Planning Update

- Scope and cost changes for the Doubs Corridor projects

July 2024 Planning Update

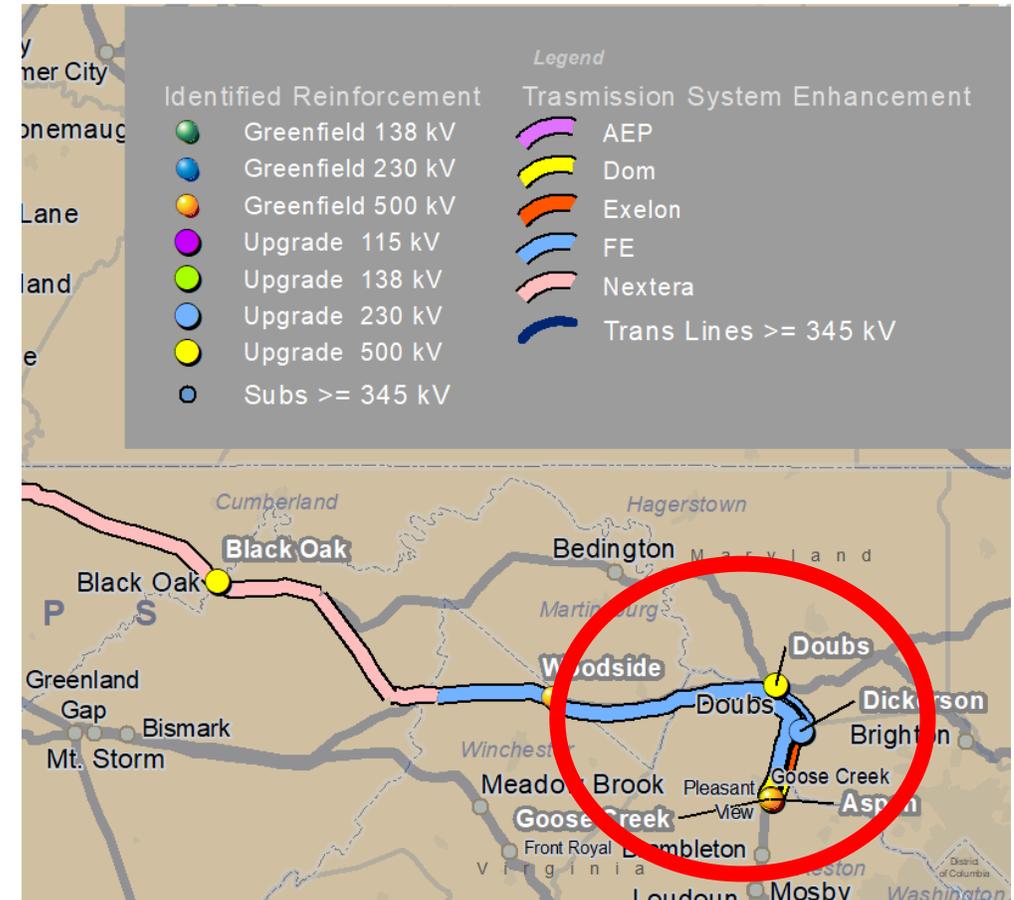
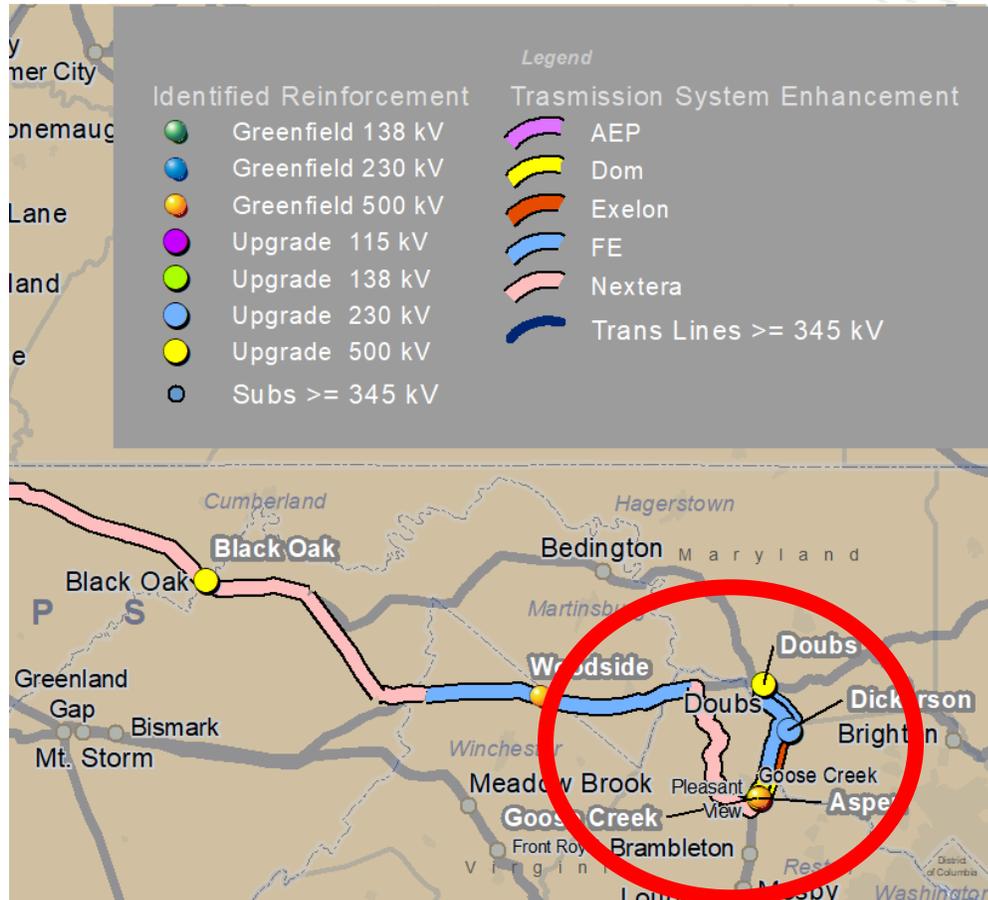
The line section from Woodside to Aspen will be rerouted from the originally proposed greenfield line route to an alternate route within existing transmission line rights of way along the Doubs Corridor containing the rebuilt Doubs – Goose Creek and the new Doubs – Aspen 500 kV lines. This reroute is the outcome of successful collaboration between NextEra and the incumbent Transmission Owners to determine the most feasible route and minimize area impact for the new Woodside to Aspen 500 kV line segment.

As part of this change, the new 500 kV line from Woodside will now terminate into Goose Creek substation due to space constraints within the Corridor and also to minimize unnecessary line crossings

TO	Scope	Change Status	Original Cost	New Cost	Cost Change
NextEra	B3800.119 – New 500 kV line – Woodside-Aspen	Cancel	\$71.72	\$0	- \$71.72
FE	B3800.105 – Rebuild 16 miles Millville-Doubs 138 with 500 kV overbuild	Revise	\$52.35	\$147.45	+ \$95.10
FE	B3800.128 – New 500 kV lin on the Millville-Doubs structures	New	\$0	\$13.20	+ \$13.20
FE	B3800.129 – New Woodside-Goose Creek 500 kV line	New	\$0	\$115.30	+ \$115.30
Dom	B3800.120 – Terminate line into Good Creek.	Revise	\$30.49	\$30.49	+ \$0
Dom	B3800.375 – New Goose Creek-Woodside 500 kV line	New	\$0	\$15.60	+ \$15.60
					+ \$167.48
